9.5 Other Auxiliary Systems

The information in this section of the reference ABWR DCD, including all subsections, tables, and figures, is incorporated by reference with the following departures and supplements.

STD DEP T1 3.4-1	STD DEP 9.5-2 (Figure 9.5-3, replaced entire figure)
STP DEP 1.1-2 (Figures 9.5-2, 9.5-4 and 9.5-5)	STD DEP 9.5-3
STP DEP 1.2-2 (Table 9.5-5)	STD DEP 9.5-4
STD DEP 8.3-1	STP DEP 9.5-6 (Figure 9.5-6)
STD DEP 9.4-2 (Table 9.5-5)	STP DEP 9.5-7 (Table 9.5-5)
STD DEP 9.5-1	STD DEP Admin

Figure 9.5-2 Outline - Telephonic Communication System for Single Unit of STP 3 or 4

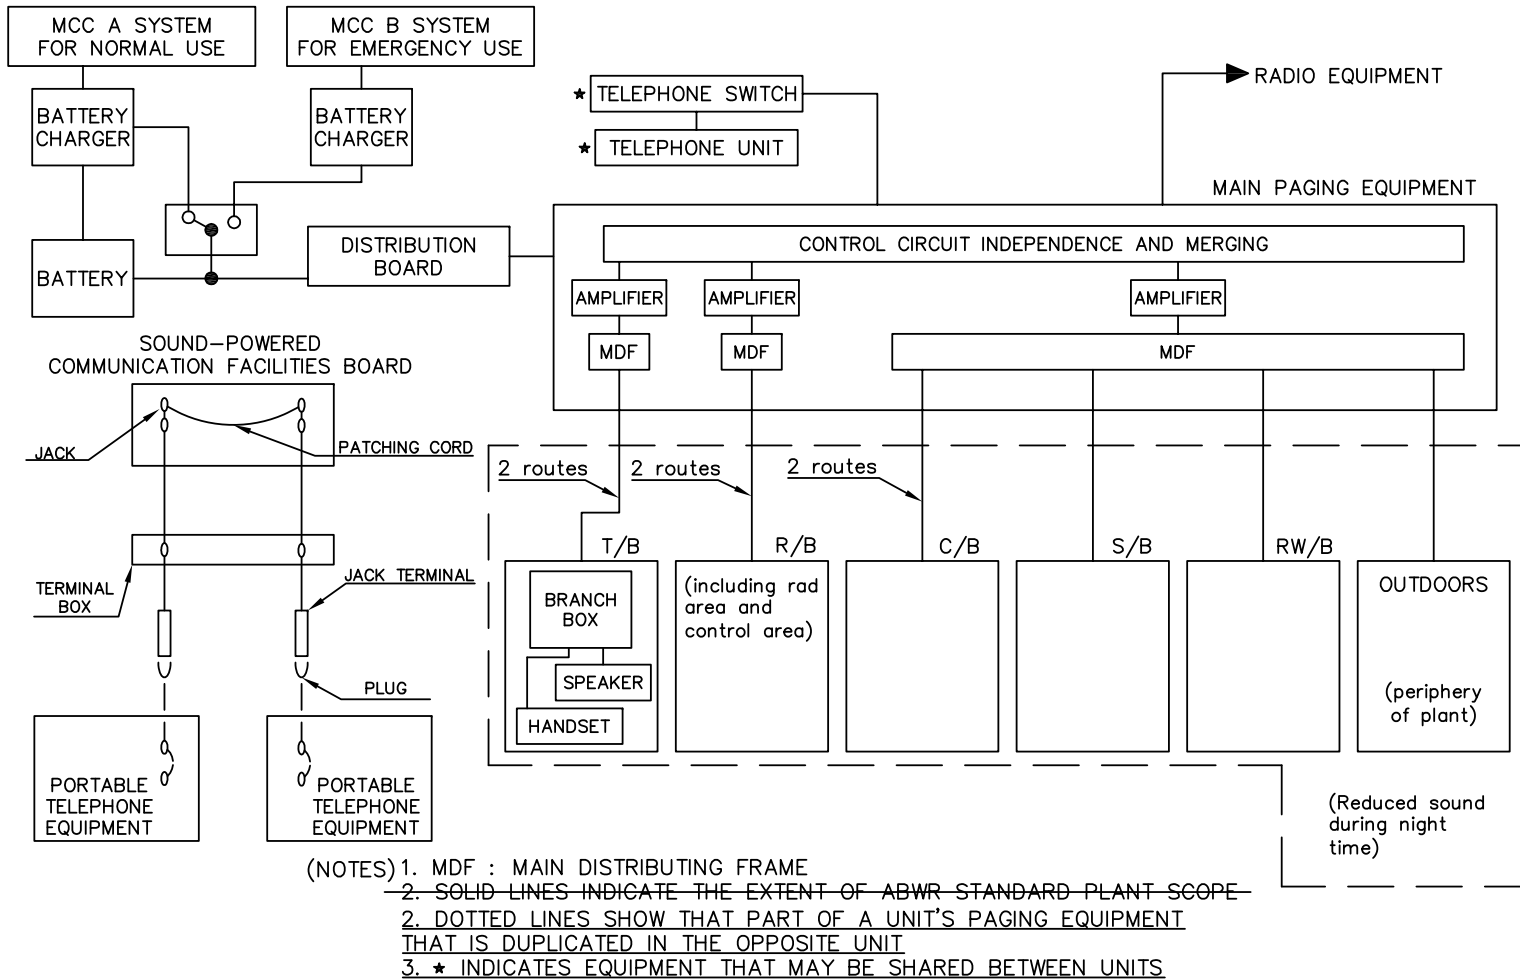
At STP 3 & 4, a common communication system is used to provide plant-wide communications between the dual units. The communication system is not safety-related. A common communication system providing plant wide communications is a safety enhancement since it allows for ease of communication between units. The representative outline of the common communication system is shown in Figure 9.5-2 for STP 3 & 4.

Figure 9.5-3 Lower Drywell Flooder System Arrangement/Configuration

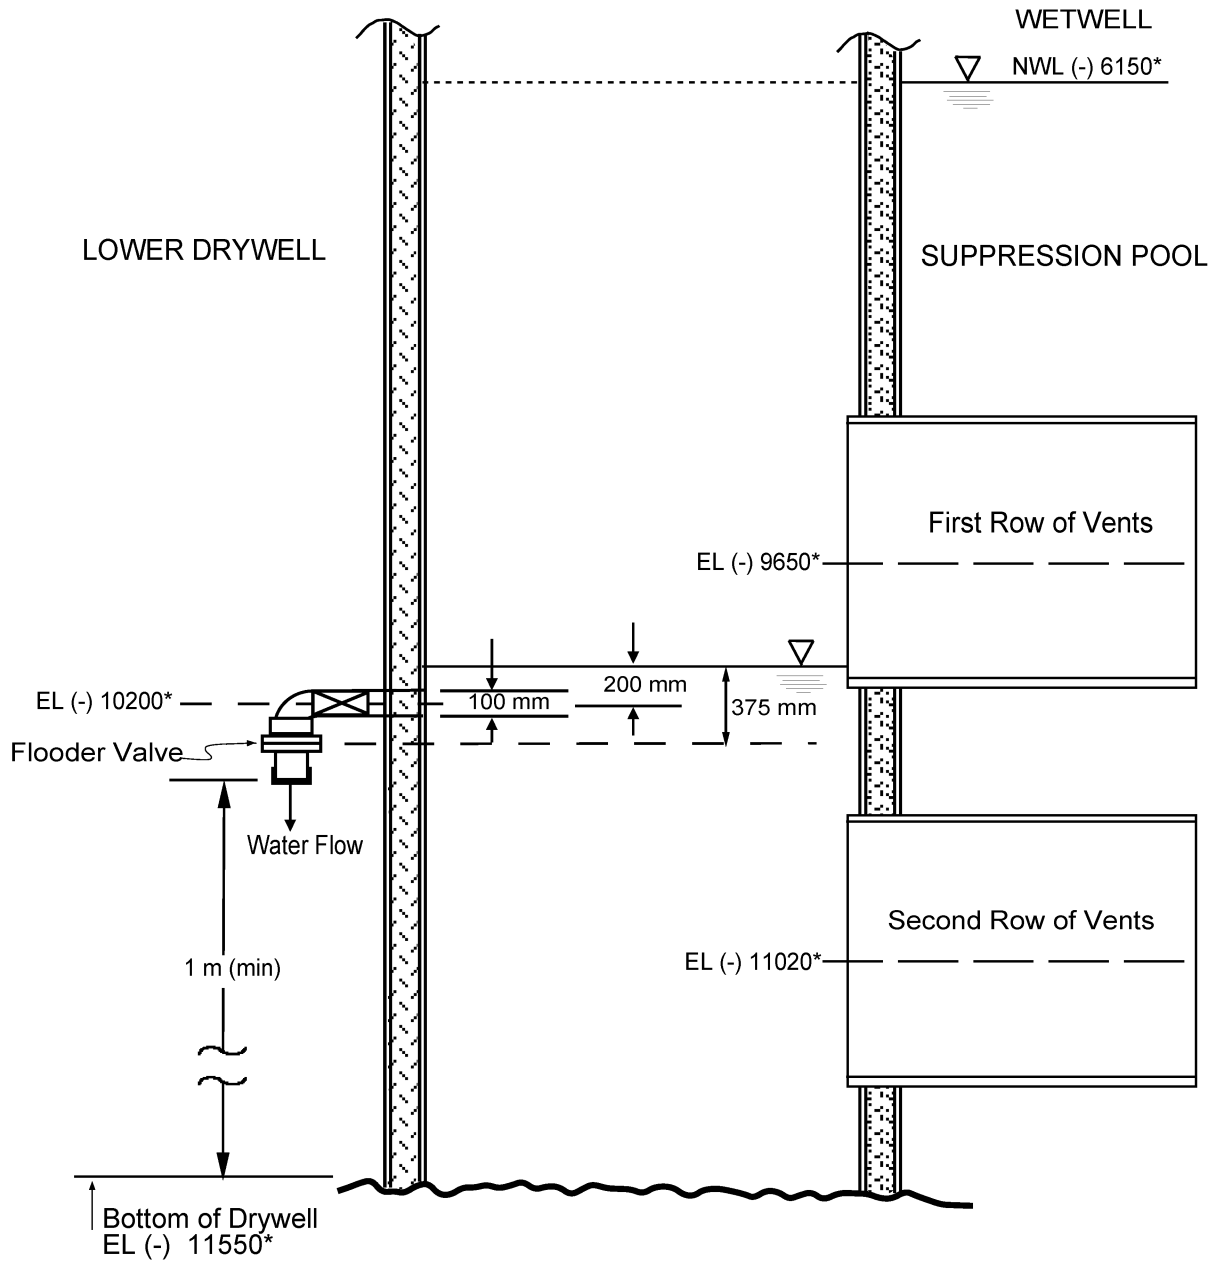
STD DEP 9.5-2

The LDF, shown schematically in Figure 9.5-3, provides a flow path for suppression pool water into the lower drywell area during severe accident scenario that leads to core meltdown, vessel failure, and deposition of molten corium on the lower drywell floor. Molten corium is a molten mixture of fuel, reactor internals, the vessel bottom head and control rod drive components. The flow path is opened when the lower drywell airspace temperature reaches 260°C ± 10°C.

The LDF consists of ten pipes that run from the vertical pedestal vents into the lower drywell. Each pipe ~~contains~~ has an isolation valve and a fusible plug valve connected to the end of the pipe that extends into the lower drywell ~~by a flange~~. The fusible plug valves open when the drywell air space ~~(and subsequently the fusible plug)~~ temperature reaches 260°C ± 10°C. When the fusible plug valves open, a minimum of 10.5 L/s of suppression pool water will be supplied through each floodor pipe (105 L/s total) to the lower drywell to quench the corium, flood the lower drywell and remove corium decay heat, which is estimated at 1% of rated thermal power. The flow rate is based on a minimum hydrostatic head of 200 mm above the floodor pipe inlet centerline and takes the frictional losses through the floodor pipe and fusible plug valve into account.
